No. 87-13

Power Steering Bracket Modification When Installing Fresh Water Cooling on 1987 MCM 305/350 CID Engines

Figure 1.

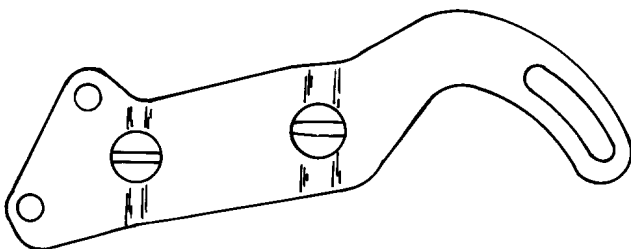
Some 1987 305/350 CID engines were produced with a power steering bracket that may interfere with the heat exchanger when installing fresh water cooling. If an interference does exist remove bracket and modify as shown in Figure 1. The bracket can be modified using a grinding wheel.

Figure 2.

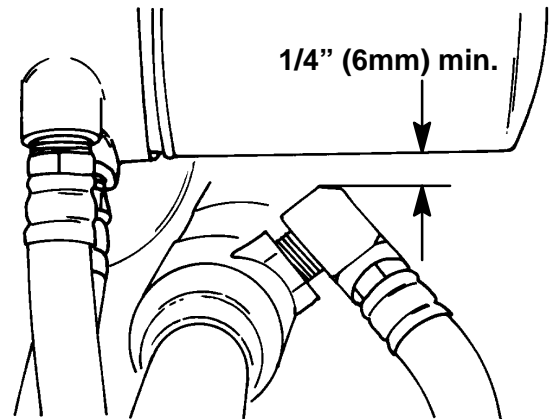
Later engines are being produced with a redesigned bracket (Figure 2) which allows for greater clearance between the bracket and the heat exchanger.

Figure 4.

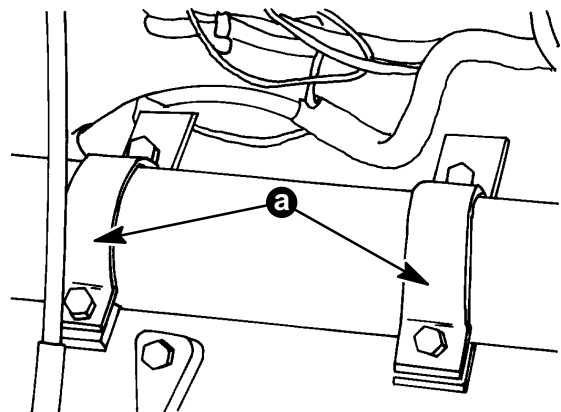
MerCruiser has received a few isolated reports that the oil cooler has rotated in its mounting clamp. If this happens the fitting on the cooler rests against the oil filter and may possibly rub thru causing an oil leak and a possible loss of oil pressure. When servicing a 575 engine, remove the mounting clamp and place a self adhesive pad (Part No. 18068) on the inside of the upper half of the clamps. (Figure 3) Position cooler so there is a minimum of 1/4" (6mm) clearance between the oil cooler fitting and oil filter. (Figure 4) Install clamp and tighten securely.

a - Place Pad Under Each Upper Half of Clamp

Figure 5.

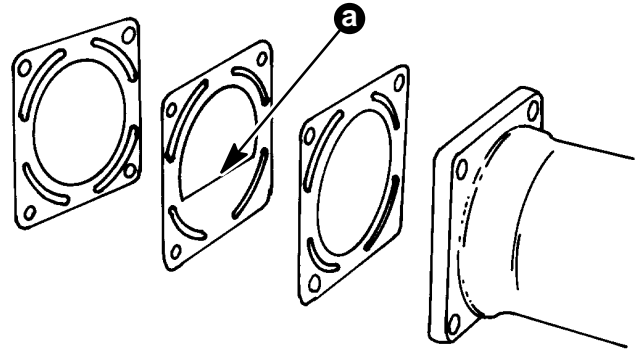
Under certain operating conditions, (usually when a high speed boat is decelerated rapidly) there is a chance water may be ingested into a 420 engine thru the exhaust system. To prevent this from happening MerCruiser has designed a baffle (Part No. 18069) that will fit between the exhaust elbow and exhaust pipe. (Figure 5)

IMPORTANT: The baffle must be sandwiched between two gaskets (Part No. 27-13848) as shown in Figure 5. Baffle must be Installed In direction shown.

a - Lip Must Face Towards Exhaust Pipe
